Addendum 2

Client: Creswell School District
Project: CHS Academic Building Improvements (Primary) Project
Date: March 5, 2026
To: Interested Bidder
Prepared by: Curt Wilson, AIA; Principal, Wilson Architecture

This Addendum modifies the Project Manual, Specifications, and Drawings as follows:

3 ENLARGED FLOOR PLAN - HOME EC
A7.00 1/2" = 1'-0"

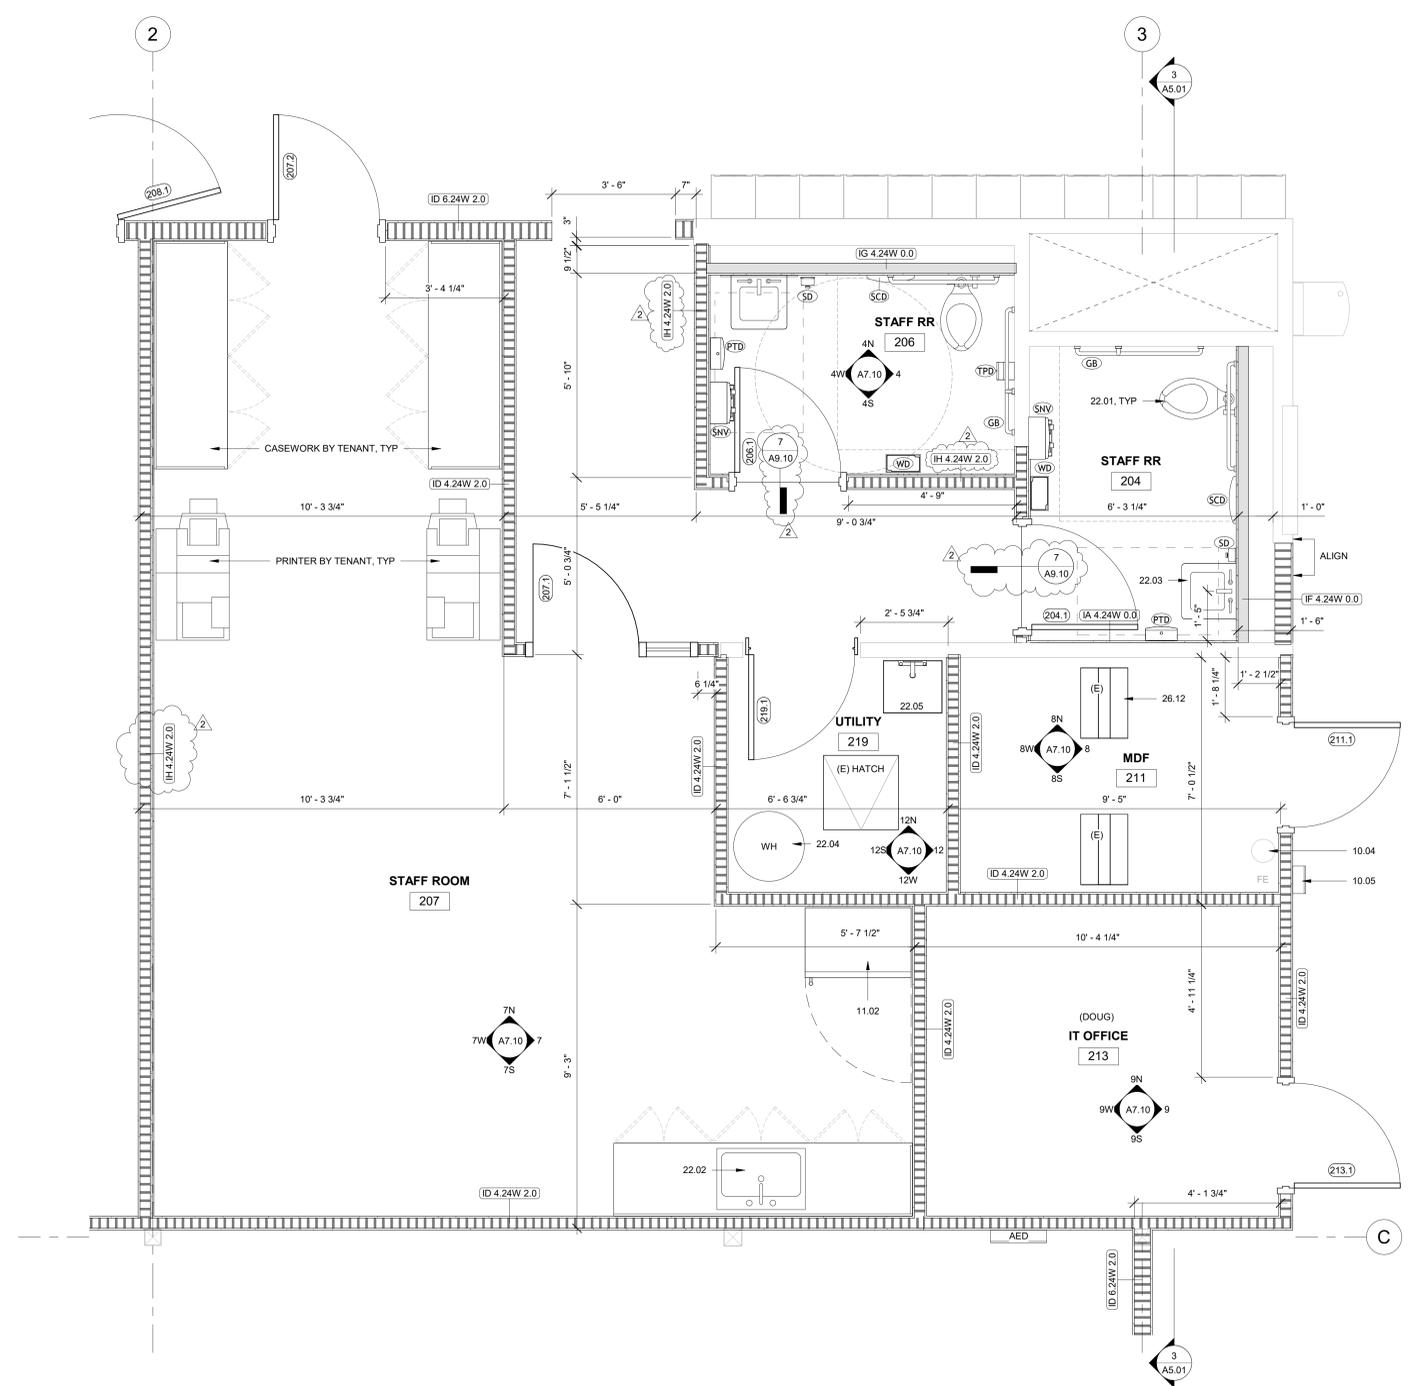
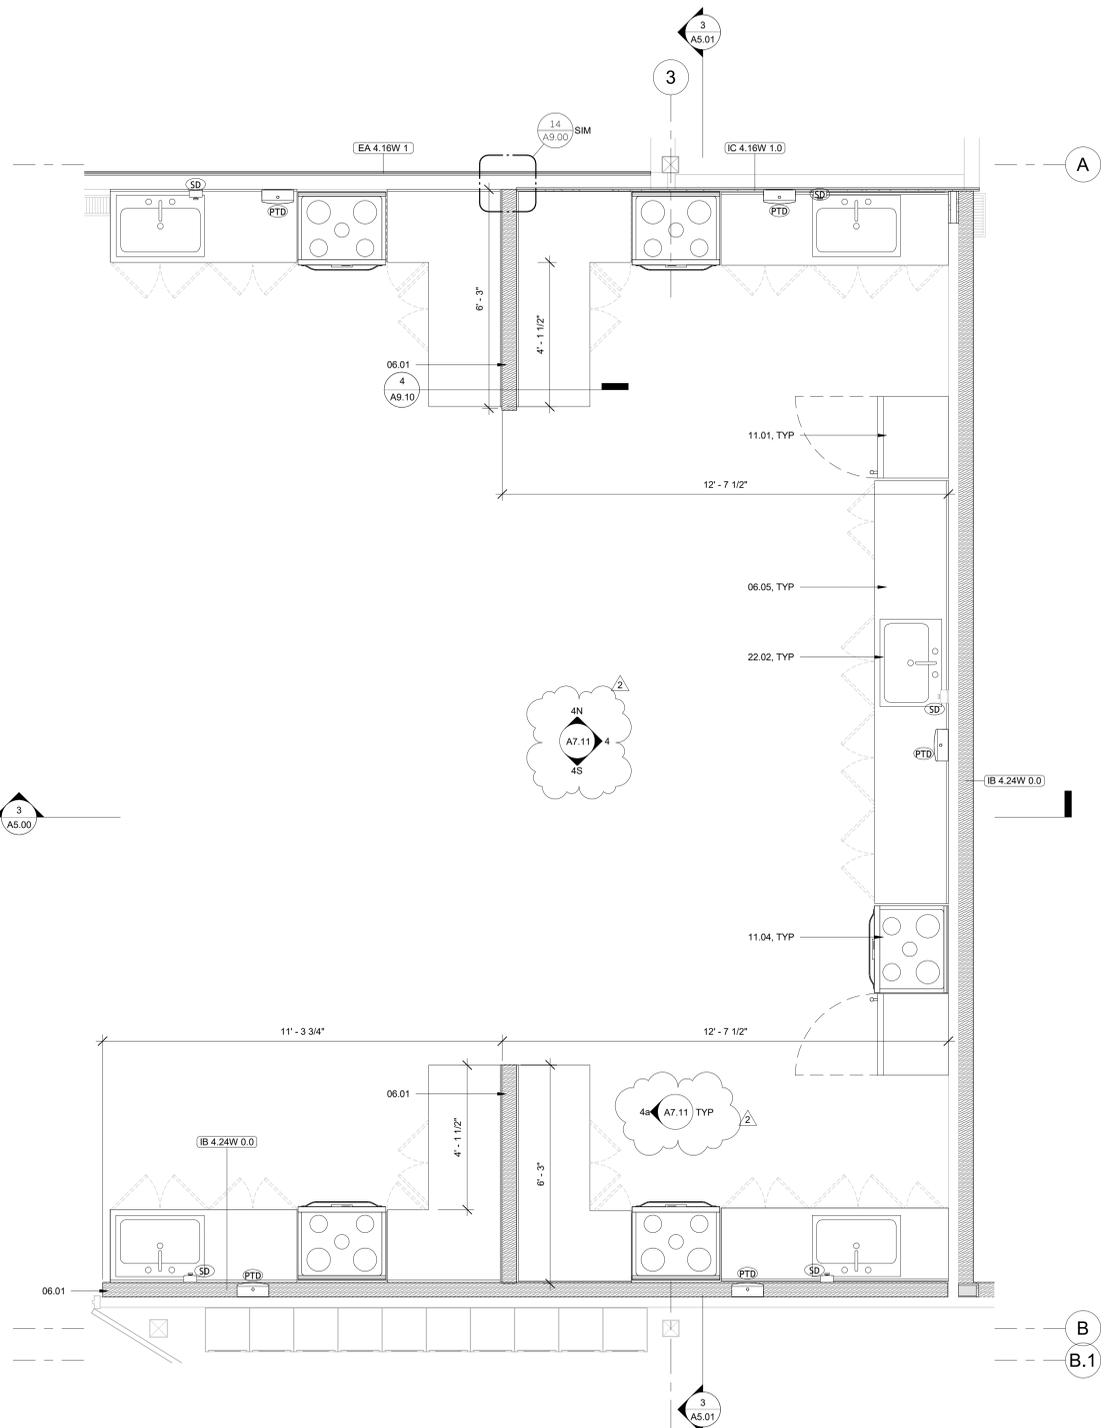
- 3.10. Sheet A7.00
- a. Replace original sheet with attached version. A brief summary of the changes include:
 - Add elevation reference to Home Ec.
 - Update wall tags for added wall assembly and add detail reference.

1
A7.01 ENLARGED FLOOR PLAN - AREA B RR
1/2" = 1'-0"

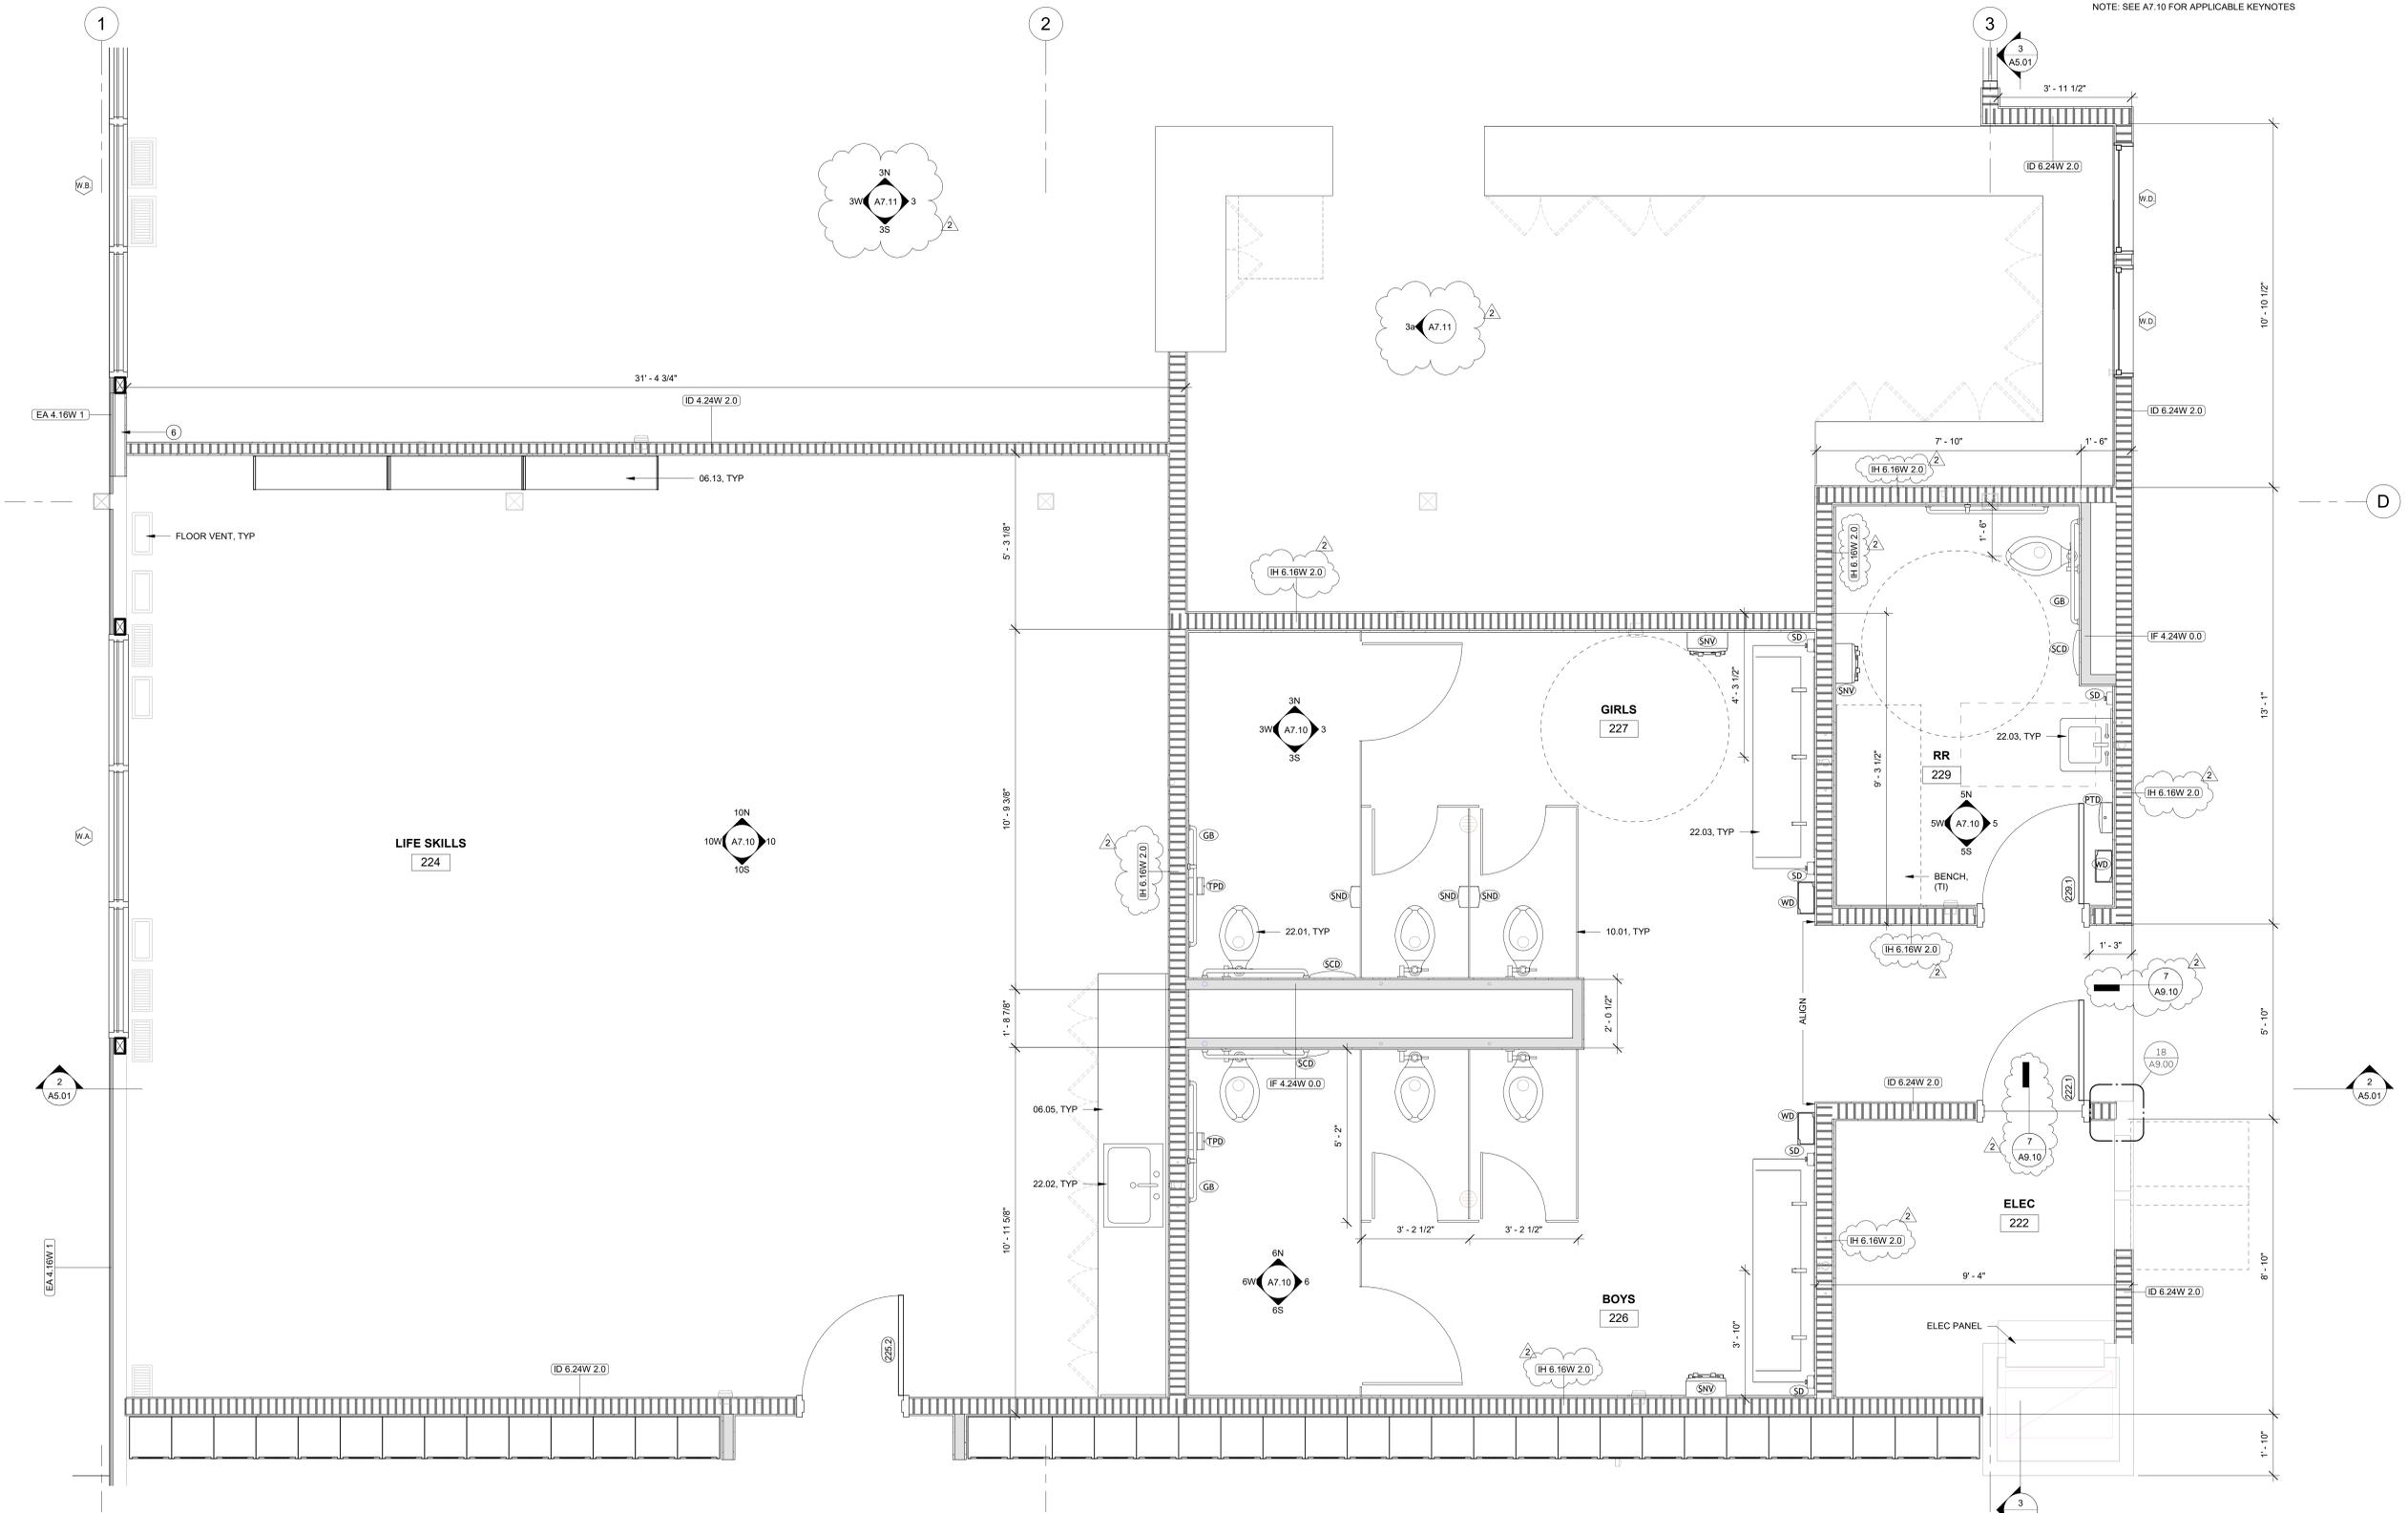
- 3.11. Sheet A7.01
- a. Replace original sheet with attached version. A brief summary of the changes include:
 - Add elevation reference to Library.
 - Update wall tags for added wall assembly and add detail reference.

4 HOME EC 205
A7.11 1/4" = 1'-0"

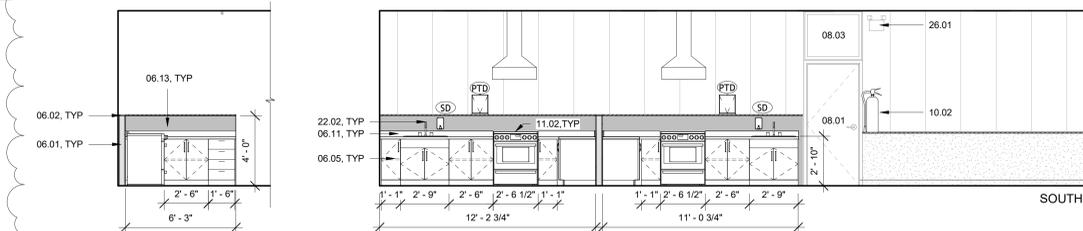
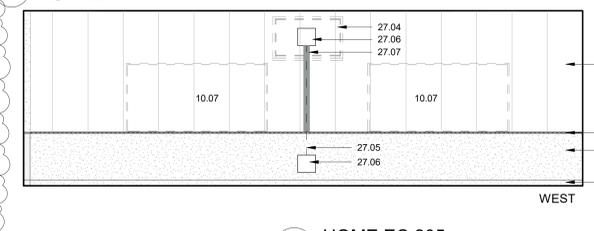
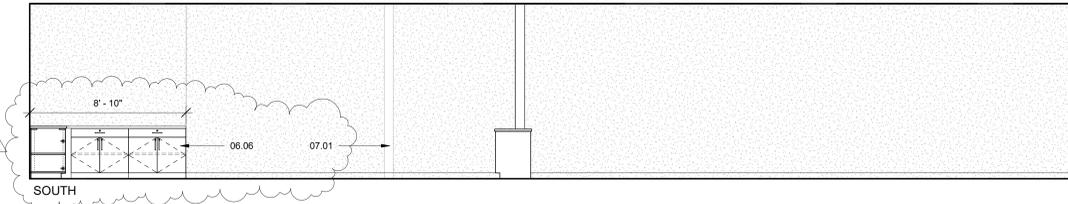
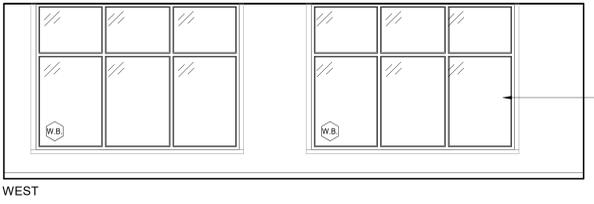
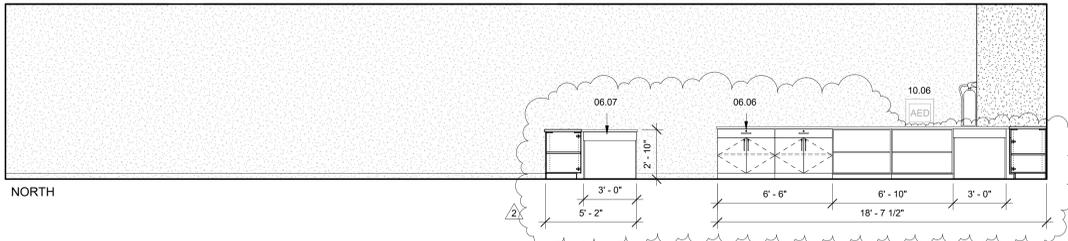
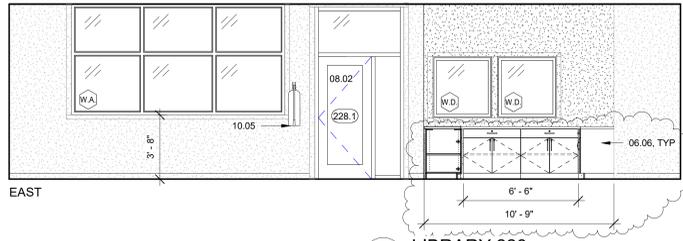
- Add dimensions and update casework in Home Ec & Library.

11 WALL TRANSITION (E) TO (N)
A8.00 3" = 1'-0"

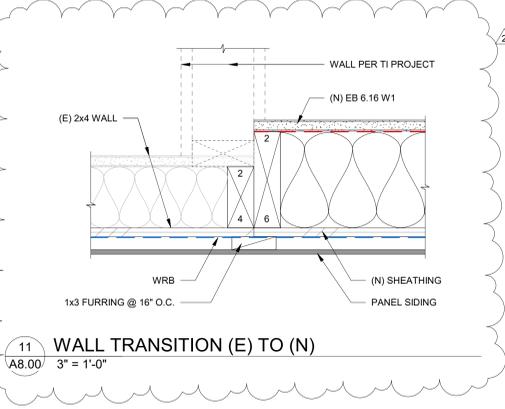
- Add exterior wall detail.

6 TRANSOM WINDOW MULLION
A9.10 3" = 1'-0"

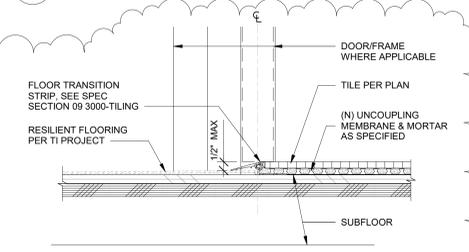
- Add window mullion and floor transition details.
